INITIAL TRAFFIC STUDY

SUBJECT: US 60 Traffic Study

Item No. 5-275.00 Initial Traffic Analysis

Project Background and Study Area

Figure 2: Alternative 2

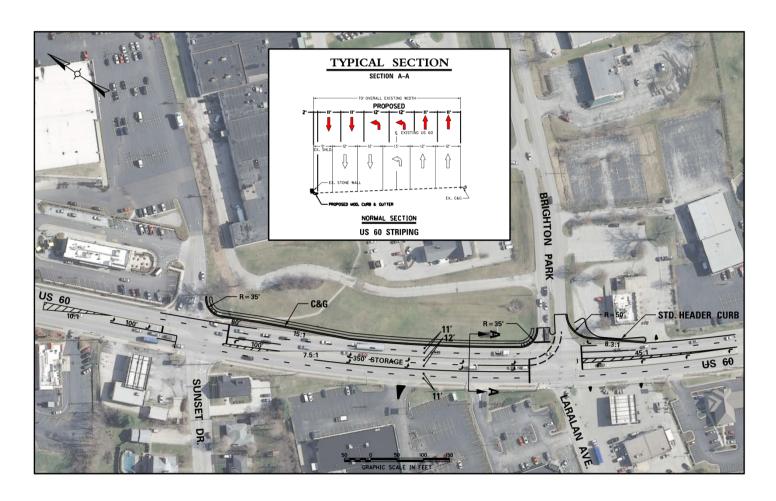
- 2. <u>Alternative 2</u>: Includes improvements in Alternative 1, further narrows the through travel lanes on US 60 and creates a dual left turn lane on US 60 for southbound vehicles turning left onto Brighton Park Boulevard. Signal phasing was adjusted to allow protected-only left turns at the Brighton Park Boulevard intersection, and signal timing and offsets were optimized as well.

A preliminary planning level design was prepared to assist with the evaluation / determination of adding a second left turn lane. **Figure 2** on the following page illustrates the layout of this Alternative. To accommodate the second left turn lane, all lanes were shifted to the east to utilize the existing shoulder. Also, the through travel lanes were reduced to 11 feet with the turn lanes at 12 feet. The low stone wall constructed along the NB lanes between the two intersections would be impacted

however, part of the wall could be left in place. Final design plans would need to be developed to evaluate the full impact to the wall.

To summarize, Alternative 2 with the dual left turn lanes provides the overall best improvement in traffic operations. The recommendation from this memorandum would be to implement Alternative 2 pending the determination by the KYTC that the additional improvement cost justifies the expense. Otherwise, Alternative 1 (original design by KYTC) will provide some measured relief in traffic operations.

It should be noted that this recommendation is a preliminary design based on aerial mapping. KYTC should confirm lane widths, both existing and proposed, will fit within the existing typical sections, excluding areas with right-turn lanes.
